APPEAL SUMMARY

Appeal ID: 21938	Project Address: 7200 NE Airport Way
Hearing Date: 9/25/19	Appellant Name: Tom Jaleski
Case No.: B-018	Appellant Phone: 9712385266
Appeal Type: Building	Plans Examiner/Inspector: David Bartley, Joe Thornton, Corey Stanley
Project Type: commercial	Stories: 2 Occupancy: A-3 Construction Type: I-A, II-B
Building/Business Name: PDX Concourse C	Fire Sprinklers: Yes - throughout, on wall
Appeal Involves: Erection of a new structure, Reconsideration of appeal	LUR or Permit Application No.: 19-175691-CO and 19-175835-MT
Plan Submitted Option: pdf [File 1] [File 2] [File 3]	Proposed use: Airport

Appeal item 1

TCORE - CONCOURSE B EXTENSION - TENANT RELOCATIONS - PHASE 3
APRON PLAN

1 LEVEL 01 - DEPLANING - APPEAL SITE PLAN
APL1.1 1/32" = 1'-0"

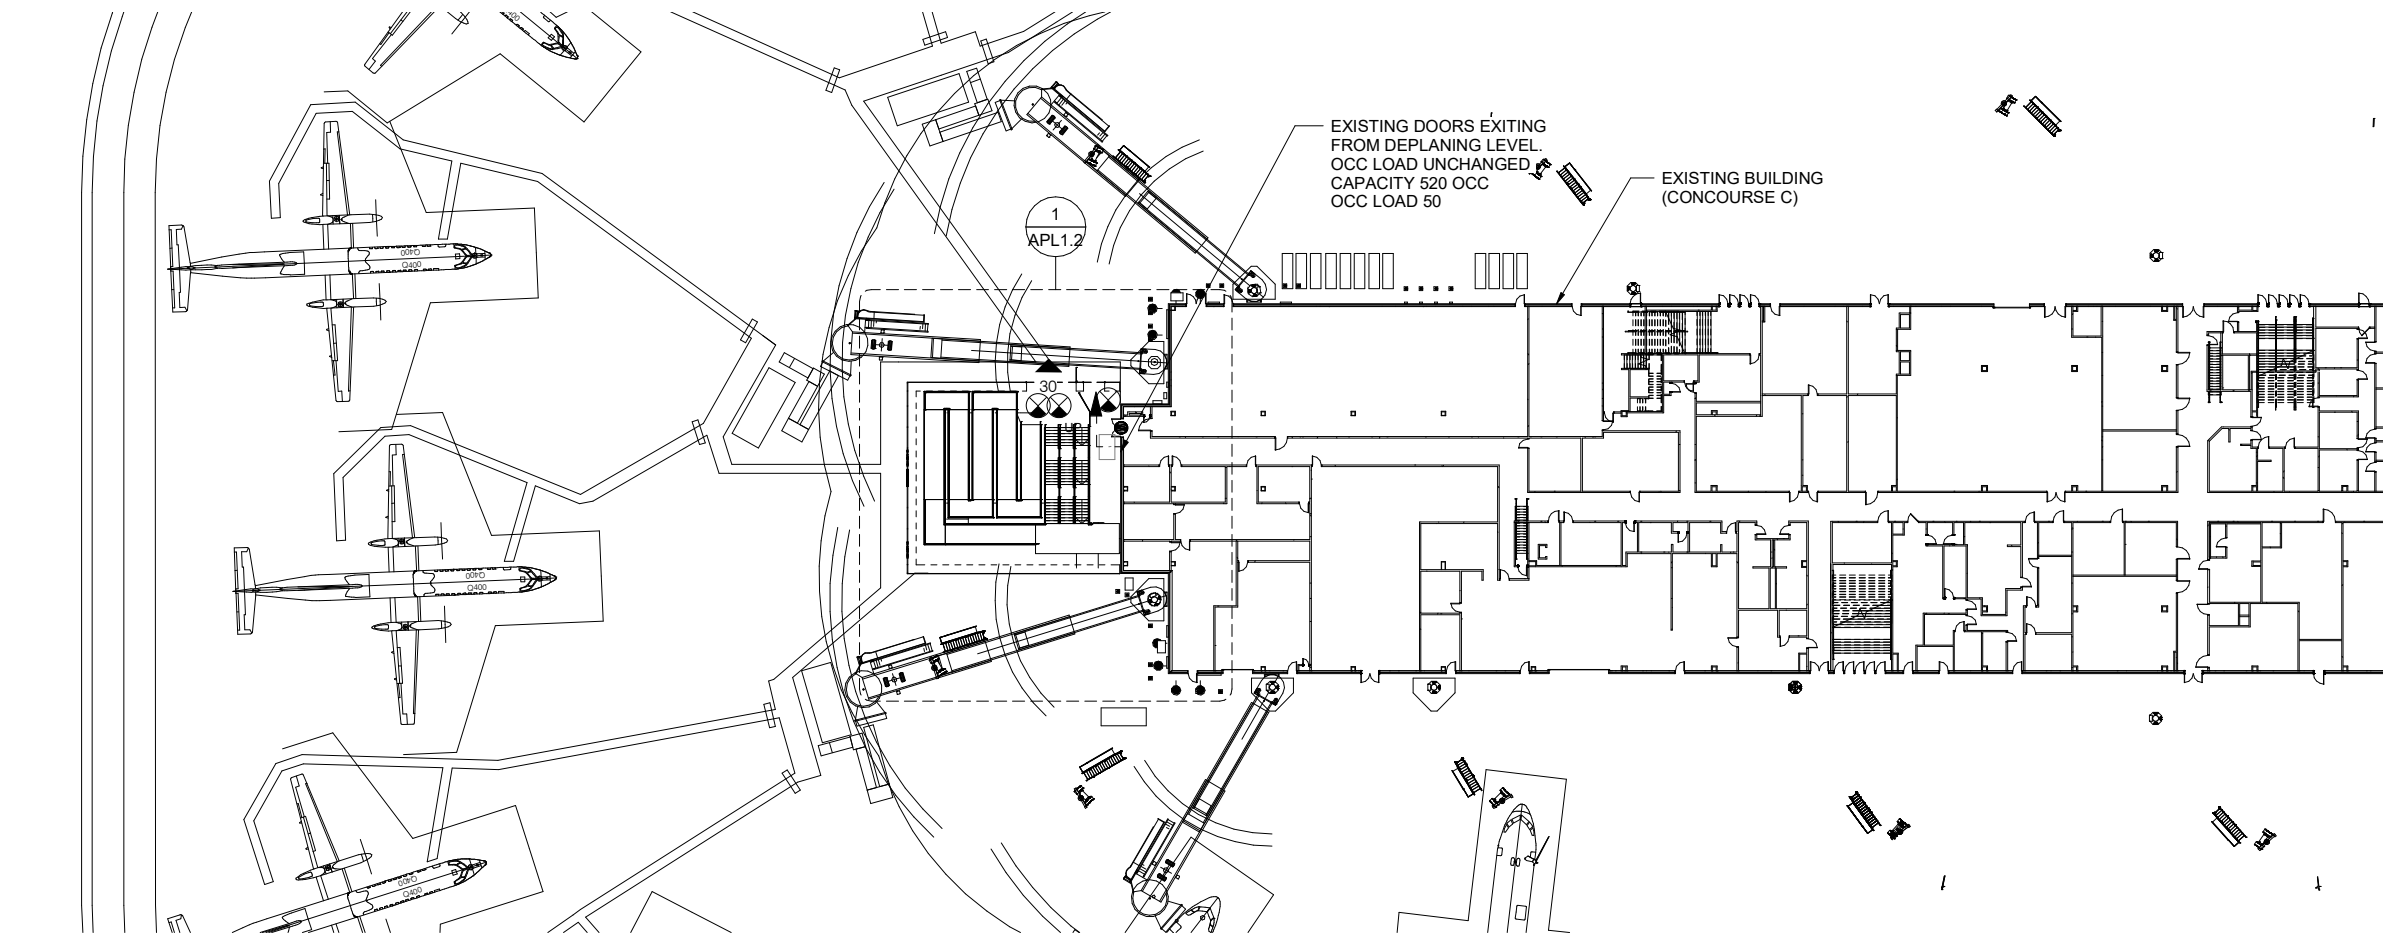
The proposed design is for the membrane structure that provides weather protection for passengers as they move into the terminal to be a pedestrian walkway per OSSC 3104 that will connect the existing terminal building with an exterior safe dispersal area per OSSC 1027.5, instead of another building. The membrane structure meets all the requirements of OSSC 3104 for pedestrian walkways and OSSC 3102 for membrane structures, except the exterior wall of Concourse C will not be fire rated and full membrane structure will not be fully sprinklered as required for pedestrian walkways that connect two buildings per OSSC 3104.5, exception 1. Since one end of the pedestrian walkway will be connected to the exterior and a safe dispersal area, equivalent protection will be provided by a single line of sprinklers along the exterior wall of the existing Concourse C building using a glycol system connected to the existing sprinkler system, designed per NFPA 13, section 7.6.

The membrane structure will be protected with a single line of sprinklers along the exterior wall of the existing Concourse C building. Additionally there will be window washing sprinklers for each recessed window and under the horizontal projections and elevated landing to wet the entire surface per OSSC 3104.5, exception 1.

Separation of membrane structure from terminal building: Granted provided the sprinkler system is installed to wet the entire exterior wall surface. A separate permit is required through the Fire Marshal's office.
